Planning Commission Meeting

5.I. 244 Mt. Zion Road Site Plan Review

DATE: December 21, 2020
TO: Adrienne Senter
FROM: Lynn Patterson
RE: **Site Plan Review – 244 Mt Zion Road Revisions**

SITE PLAN PAGE 1 OF 2 PREPARED FOR:
244 Mount Zion Rd SW

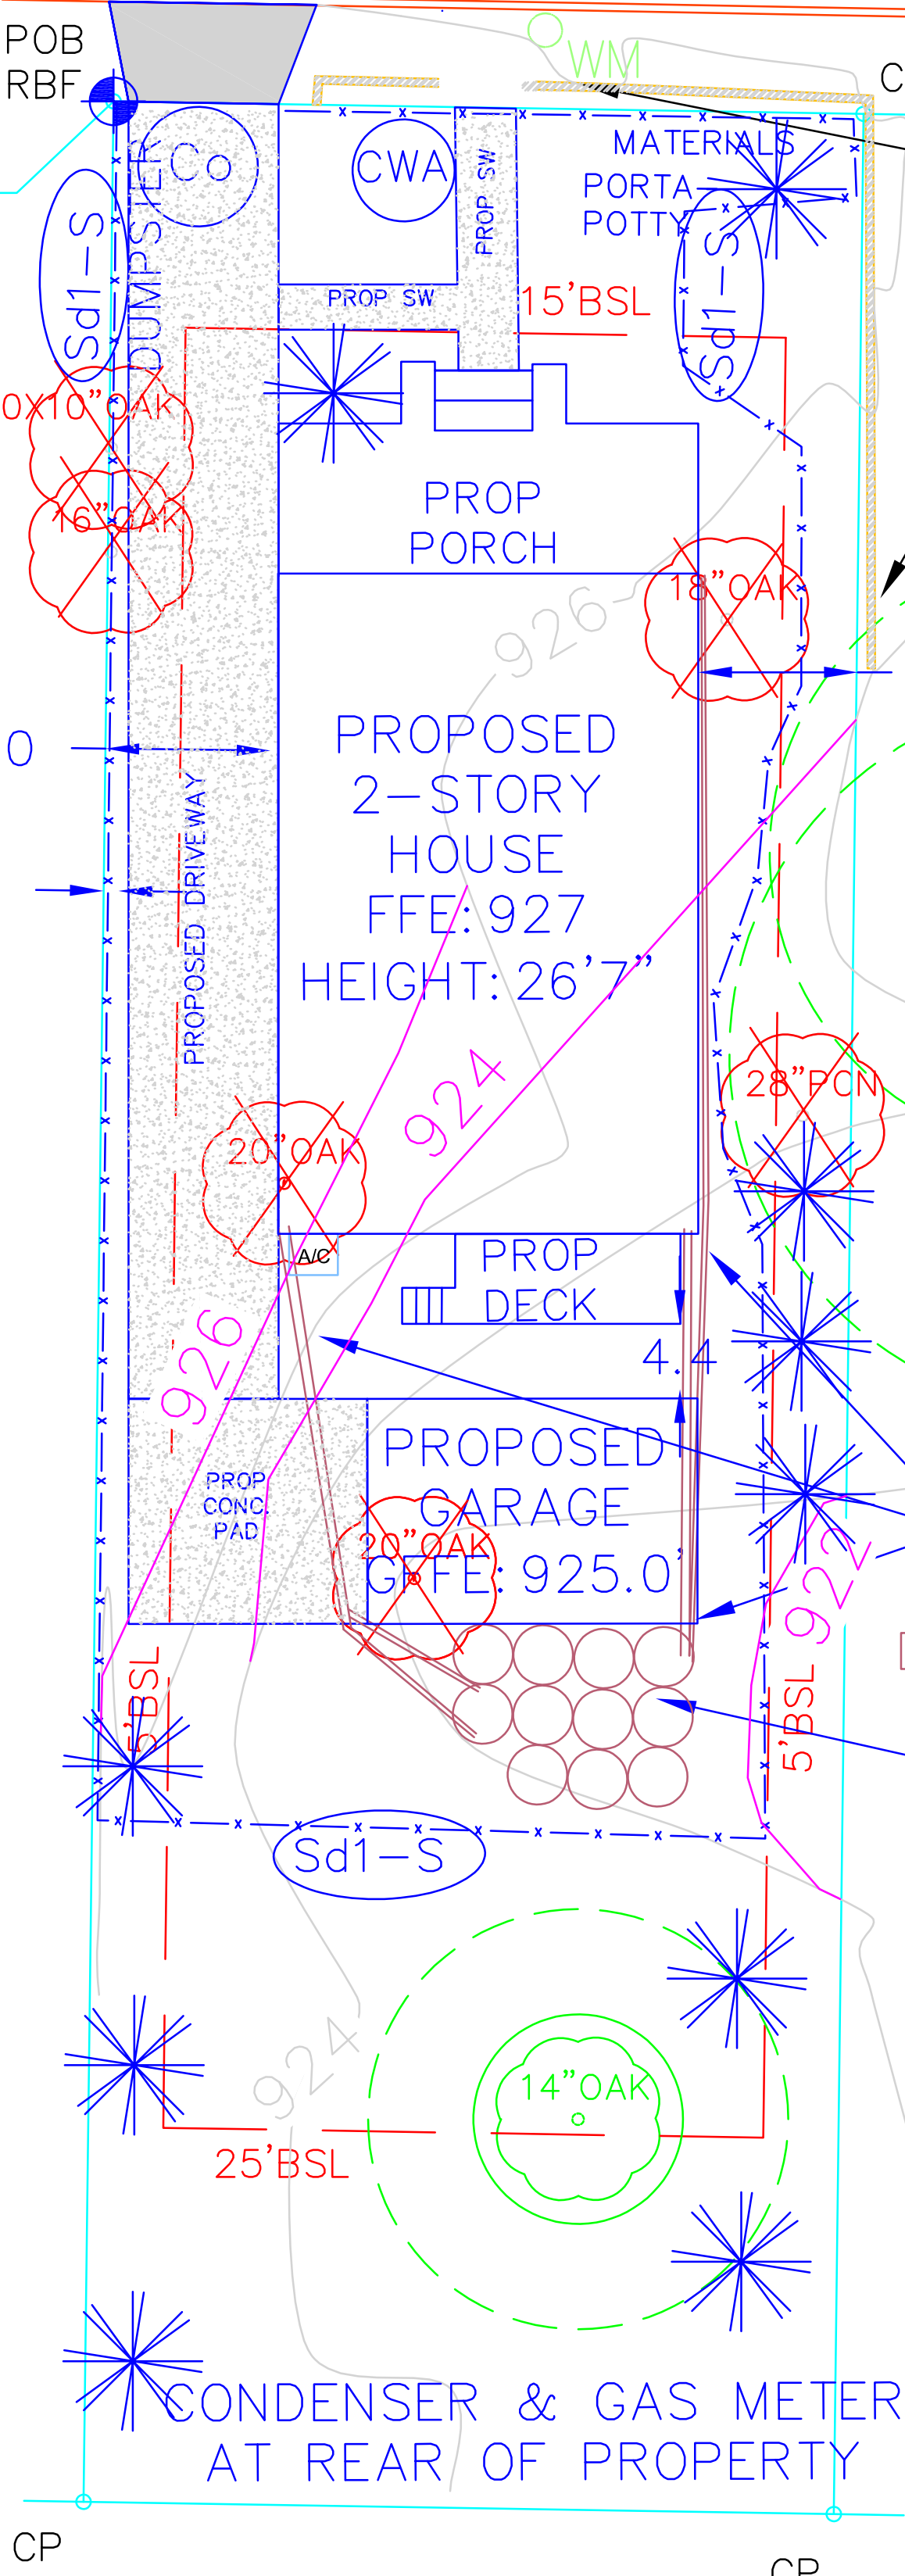
- ***According to the Architectural Site Plan Setbacks shown are:***
 - ***Front: not provided. Shown beyond the 15' setback line.***
 - ***Sides 11 and 10.6'***

Inconsistencies and incomplete information remain with regard to the site plan.

- 1. Show proposed grades***
- 2. See Arborist Comments for Tree Ordinance compliance.***
- 3. Provide an updated development schedule.***
- 4. Provide driveway cross section.***
- 5. Provide all setback dimensions***
